SUBPART 3 MINIMAL IMPACT NEW MINING OPERATIONS PERMIT APPLICATION

LIST PROJECT NAME: Iron Duke

RE: Response to MMD Technical Comments

Path: S:\Projects\gulfCoast\oroGrande\Plates\plate2.mxd

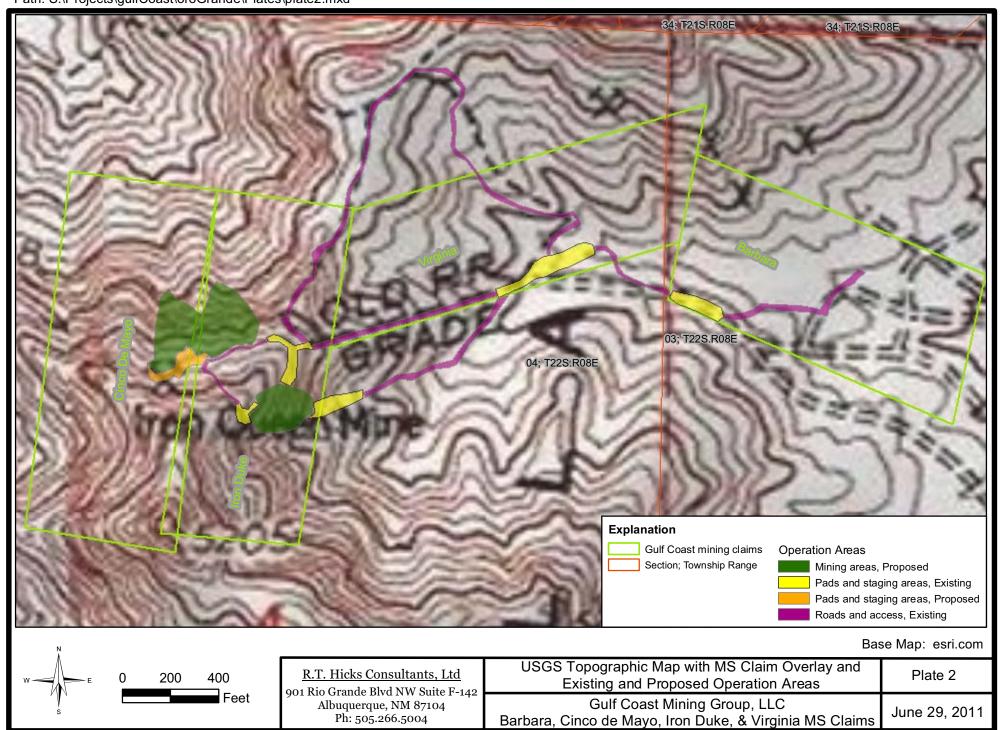
2. Pursuant to 19.10.304.D.2 NMAC, please amend Plate 2 and/or Plate 3 (maps) to include the boundaries of the proposed permit area, all previously disturbed areas, ephemeral drainages, and the access route(s) that will be utilized to access the north waste piles. Note; during the agency site visit of August 1, 2011 access to the north waste pile is not in existence.

- Boundaries of the four claims are shown in "lime green" on Plate 3A and Plate 2.
- All previously disturbed areas are included within Areas numbers 1 through 14 on plate 3A.
- Ephemeral drainages are the arroyos evident on the aerial photograph of Plate 3A. Topographic contours (in brown) are superimposed on the aerial photograph. The primary drainages are to the east with a smaller area draining to the north. These drainages are evident as "V's" pointing up the drainage on the topographic backdrop of Plate 2 and Plate 3A.
- Access to the North Side Waste Rock Pile will use Area 9 (Upper Access Road) and Area 5 (Cinco de Mayo Access and Upper Pad). This last Area was created and used
